ACCELERATED DISTRIBUTION DEMONSTRATION SYSTEM

SUBJECT: Application for amends to Licenses DPR-58 & DPR-74, changing Westinghouse fuel & reload analysis methodology.

Donald C. Cook Nuclear Plant Units 1 and 2
Docket Nos. 50-315 and 50-316
License Nos. DPR-58 and DPR-74
UNIT NO. 2 CYCLE 8 RELOAD LICENSING, PROPOSED TECHNICAL
SPECIFICATIONS FOR UNIT 2 CYCLE 8, AND RELATED
UNIT 1 PROPOSALS

Figure 2.1-1 Reactor Core Safety Limits
Four Loops in Operation

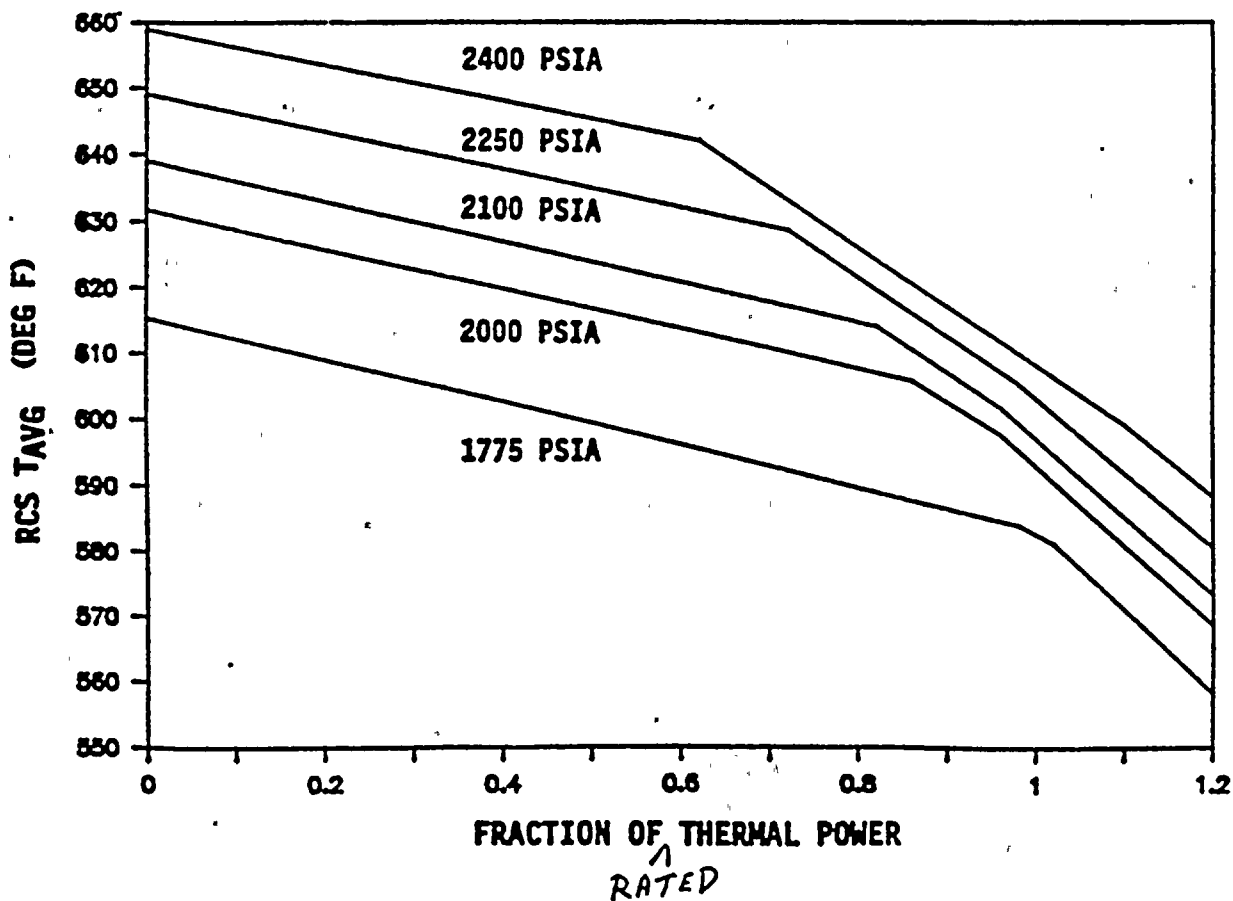
<u>SECTION, PAGE</u>	<u>CHANGE</u>	<u>REASON FOR CHANGE</u>
1.0, pg I	Add COLR to index	COLR implementation
1.12a, pg 1-3	Add COLR	COLR implementation
Figure 2.1-1, pg 2-2	Revised safety limits	Reanalysis supports VANTAGE 5 reload

- a) Reactor Core Safety Limit Curves and OTdelta-T/OPdelta-T Reactor Trip Setpoints, T/S Figure 2.1-1 and T/S Table 2.2-1, Functional Units 7 and 8.

FIGURE 3.1-3 REQUIRED SHUTDOWN MARGIN

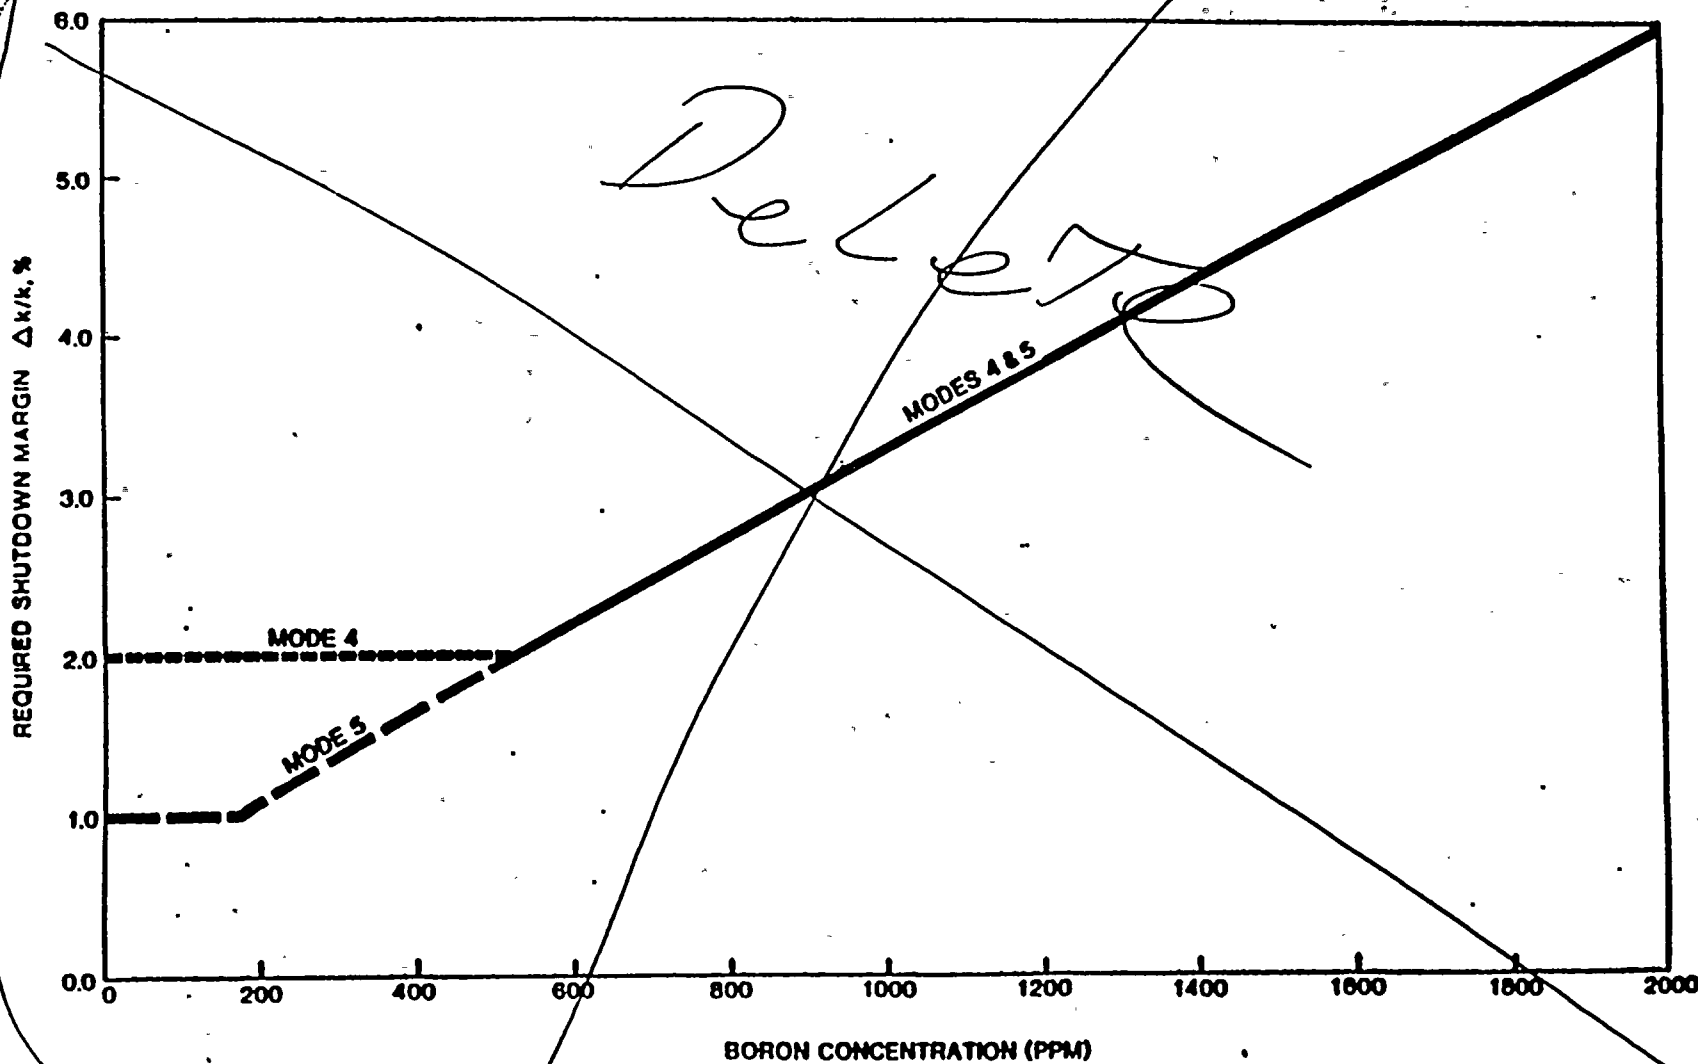
These changes are numbered 027, 032 and 033 in Attachment 3. AEP proposes to rearrange T/Ss 3/4.1.1.1 and 3/4.1.1.2 into STS format by moving the Mode 4 requirement from 3.1.1.2 to 3.1.1.1 and deleting Figure 3.1-3 and related references. In the Cycle 6 submittal the Mode 4 shutdown margin was moved from 3/4.1.1.1 to 3/4.1.1.2. The Cycle 6 change to T/S 3/4.1.1.2, which then included Mode 4 and Mode 5 in the same T/S, was a revision that reflected the results of the boron dilution accident analysis when heat removal is via the residual heat removal (RHR) system. This analysis was performed by ANF.

Figure 3.1-1
ROD BANK INSERTION LIMITS VERSUS THERMAL POWER
FOUR LOOP OPERATION

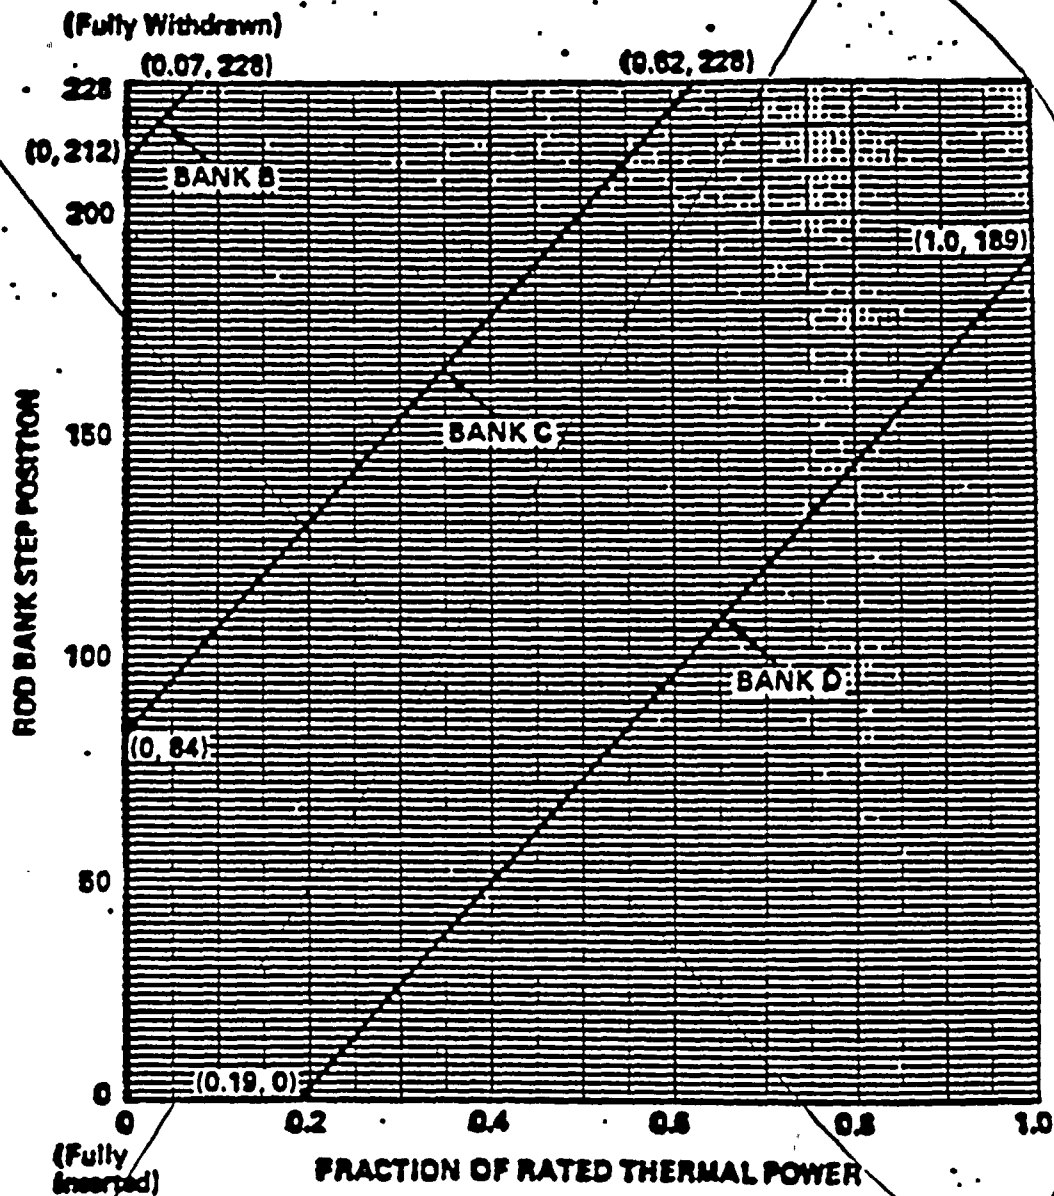
3.1.3.6 The control banks shall be limited in physical insertion as shown in Figure 3.1-1. SPECIFIED IN THE CORE OPERATING LIMITS REPORT (COLR)

DELETE THIS PAGE

<u>SECTION, PAGE</u>	<u>CHANGE</u>	<u>REASON FOR CHANGE</u>
3/4.1.3.6, pg 3/4 1-25	Relocate control rod insertion limits to COLR	COLR implementation (relocation of control rod insertion limits)
3/4.1.3.6, pg 3/4 1-26	Delete figure 3.1-1	COLR implementation
3/4.3.2.1, pg 3/4 2-1 & 2-3	Relocate axial flux difference limits to COLR	COLR implementation (relocation of AFD limits)
3/4.3.2.1, pg 3/4 2-4	Relocate axial flux difference allowable deviation Fig. to COLR	COLR implementation (relocation of AFD allowable deviation)
3/4.3.2.2, pg 3/4 2-5	Relocate F_Q limits to COLR	COLR implementation (relocation of F_Q limit)
3/4.3.2.2, pg 3/4 2-8, 2-8a & 2-8b	Relocate $K(Z)$ & $V(Z)$ figures to COLR	COLR implementation (relocation of F_Q limit)
3/4.3.2.3, pg 3/4 2-9	Relocate $F_{\Delta H}^N$ limits to COLR	COLR implementation (relocation of $F_{\Delta H}^N$ limit)
3/4.2.5.1, pg 3/4 2-15	Reformat DNB spec Change DNB parameter values and add low Tavg window	Adopt planned Cook Nuclear Plant Unit 1 spec format consistent with VANTAGE 5 reload

FIGURE 3.2-1 ALLOWABLE DEVIATION
FROM TARGET FLUX DIFFERENCE

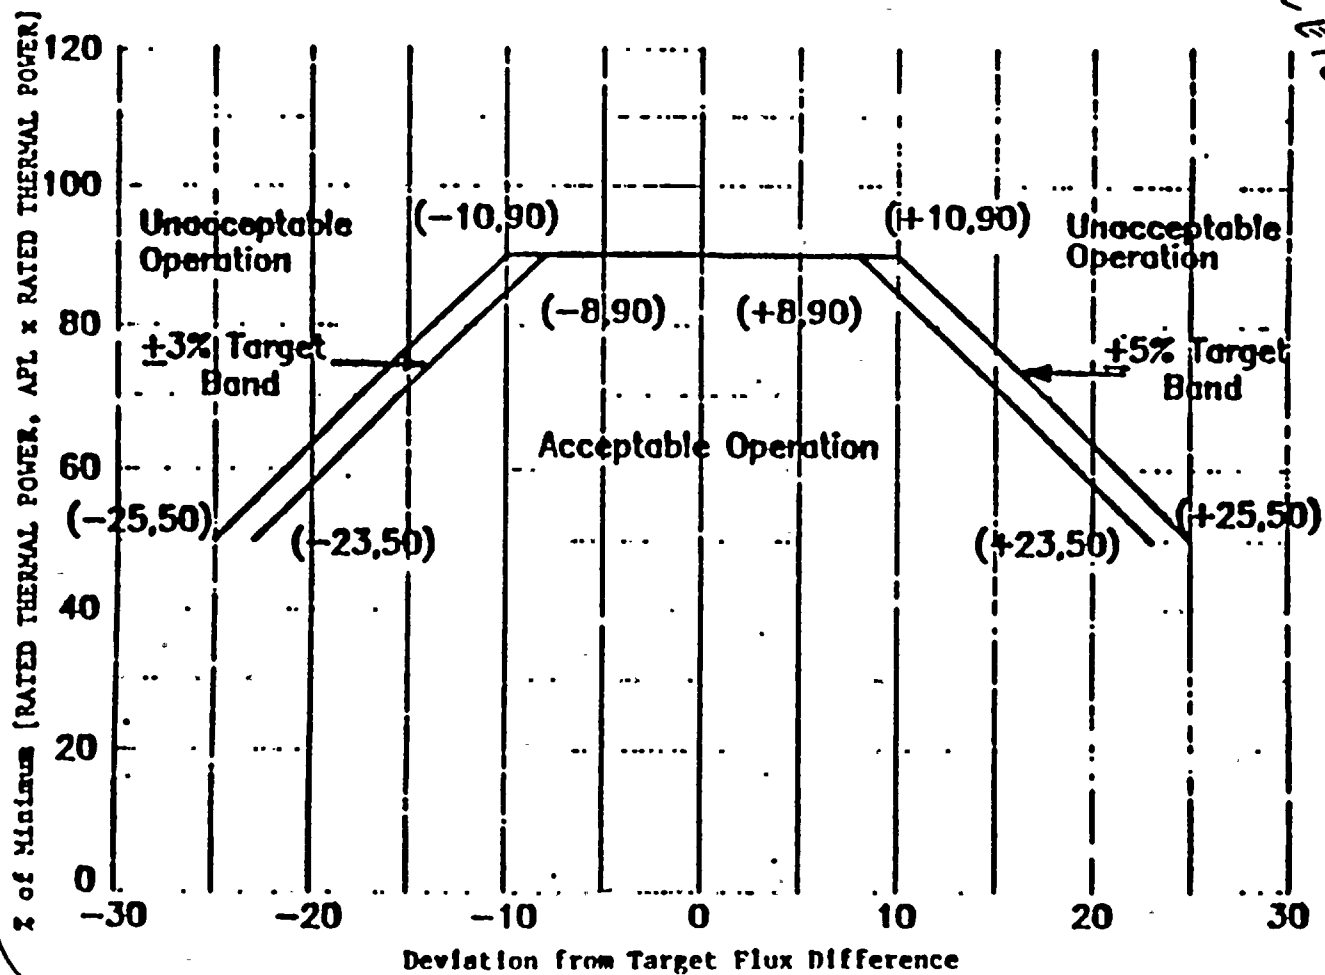
2) The indicated AFD is within the limits *Specified in The COLR* ~~shown in Figure 3-2-1~~. Otherwise, reduce THERMAL POWER to less than 50% of RATED THERMAL POWER within 30 minutes and reduce the Power Range Neutron Flux-High Trip Setpoints to less than or equal to 55% of RATED THERMAL POWER within the next 4 hours.

Specified
in the
COLR

FIGURE 3.2-2(a) D. C. COOK UNIT 2, $K(Z)$ - NORMALIZED $F_1(Z)$ AS A FUNCTION OF CORE HEIGHT FOR EXXON NUCLEAR CO. FUEL

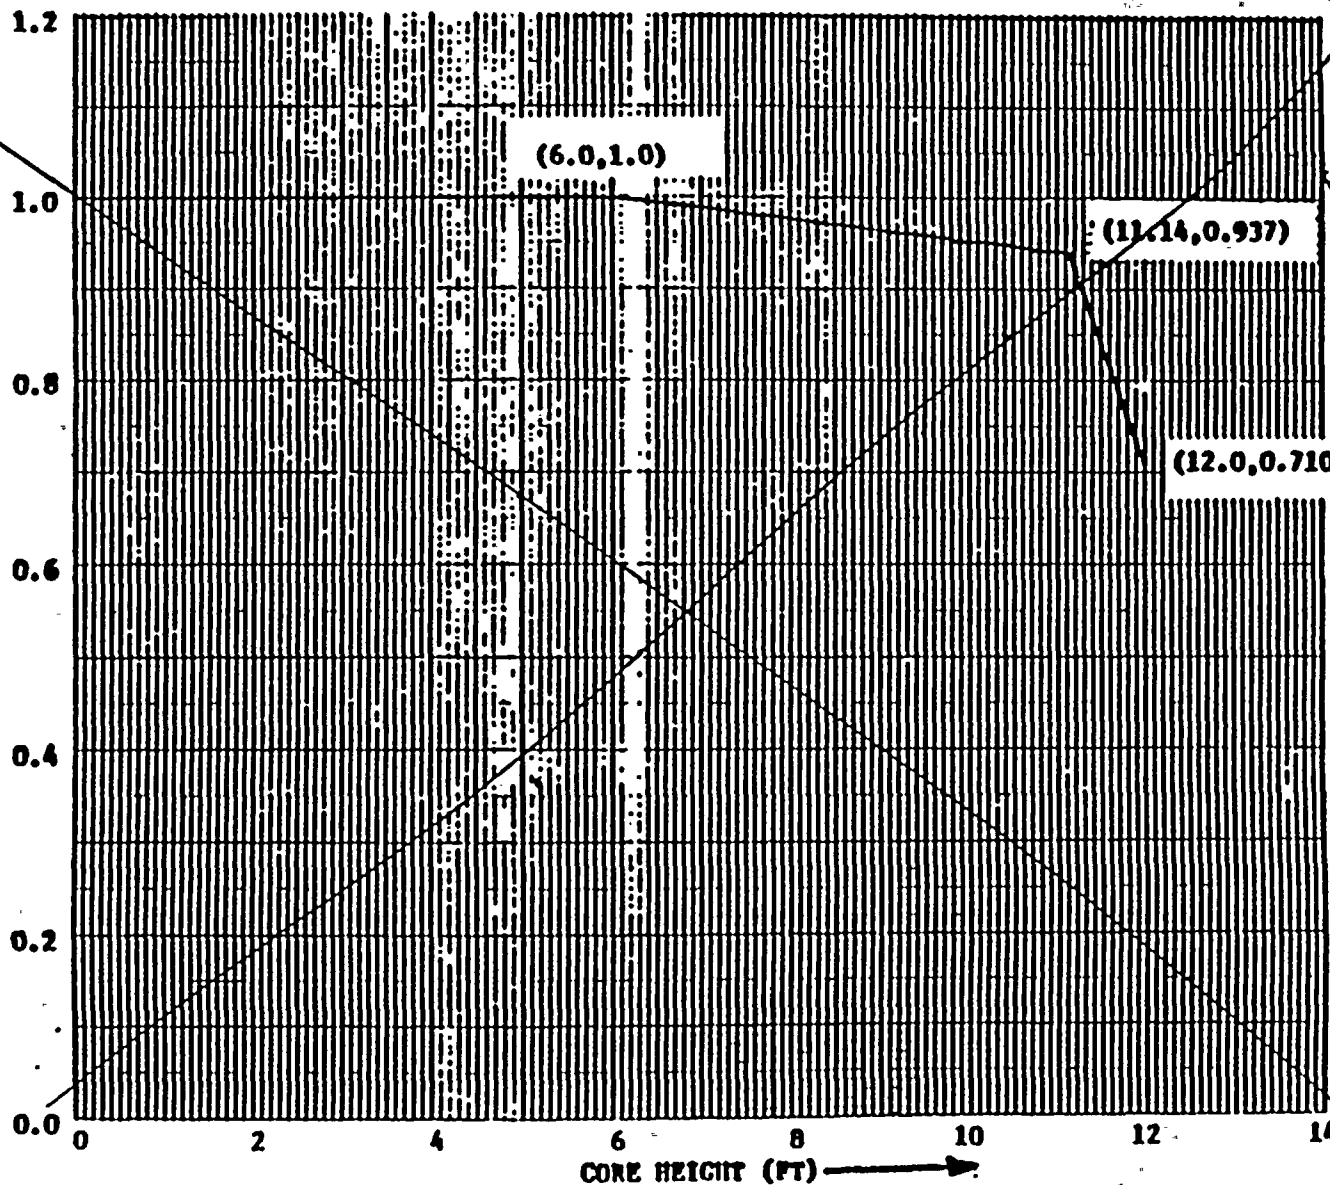
$K(Z)$ is the function obtained from Figure 3.2-2 for Westinghouse fuel and Figure 3.2-2(a) for Exxon Nuclear Company fuel. NORMALIZED $F_Q(Z)$ AS A FUNCTION OF CORE HEIGHT SPECIFIED IN THE COR

DELETE This PAGE

Figure 3.2-3 V(Z) As A Function of Core Height.

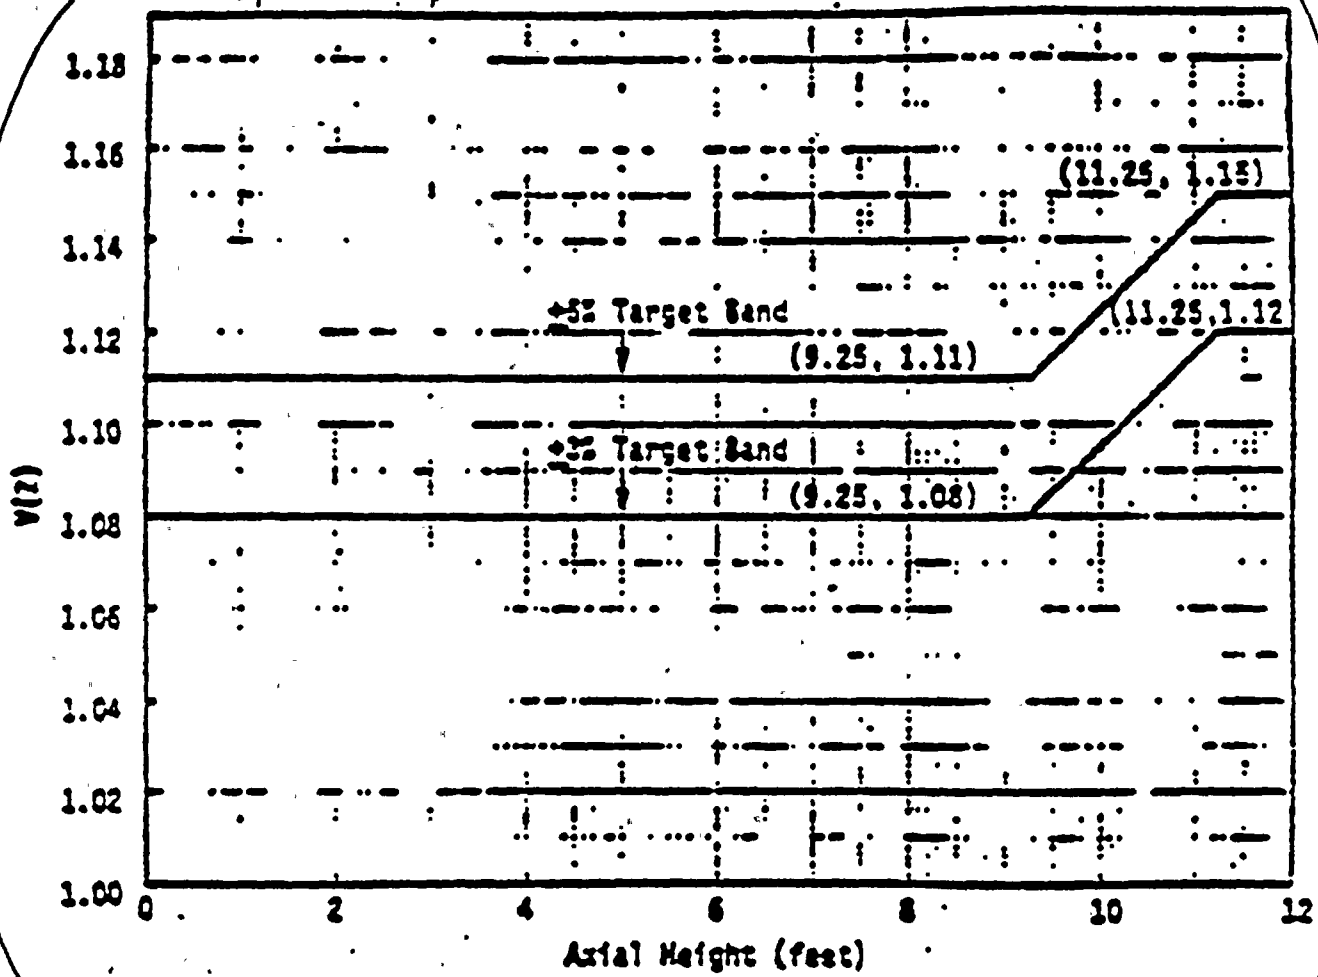
- $V(Z)$ is the function defined in The COLR Figure 3.2-3 which corresponds to the target band.

FIGURE B 3/4 2-2 ILLUSTRATIVE EXAMPLE OF
 F_{AH}^N LIMIT VERSUS PERCENT THERMAL POWER FOR EXXON FUEL

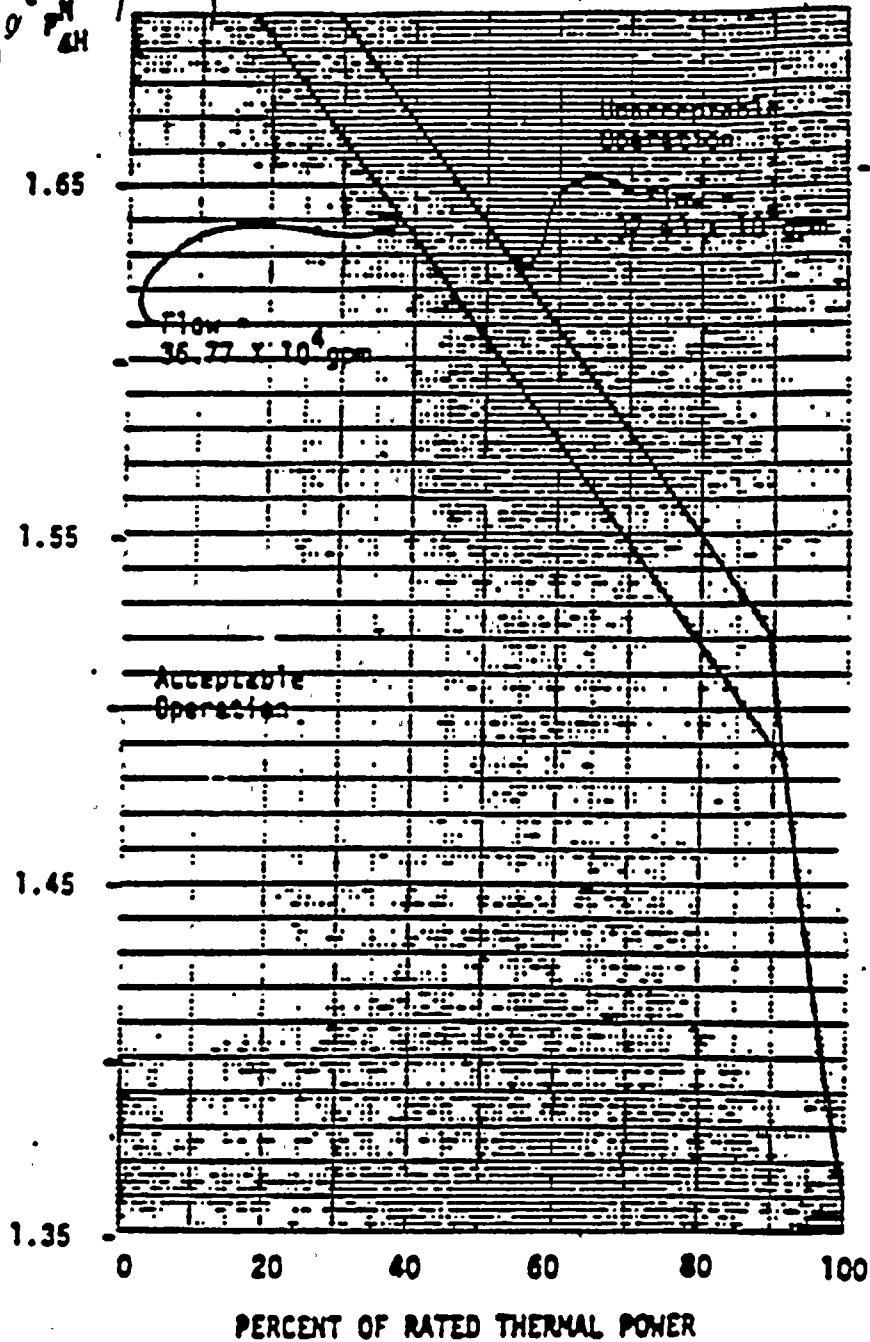
Figure B 3/4 2-2 displays two limiting DNBR $F_{\Delta H}^N$ curves for Exxon Nuclear Company fuel for flows of 36.77×10^3 gpm, and 37.63×10^3 gpm. Also displayed on Figure B 3/4 2-2 is the limit on $F_{\Delta H}^N$ which results from the LOCA analysis for Exxon Nuclear Company fuel. $F_{\Delta H}^N$ must be maintained below and to the left of both the applicable DNBR $F_{\Delta H}^N$ limit and the LOCA $F_{\Delta H}^N$ limit.

Delete This PAGE
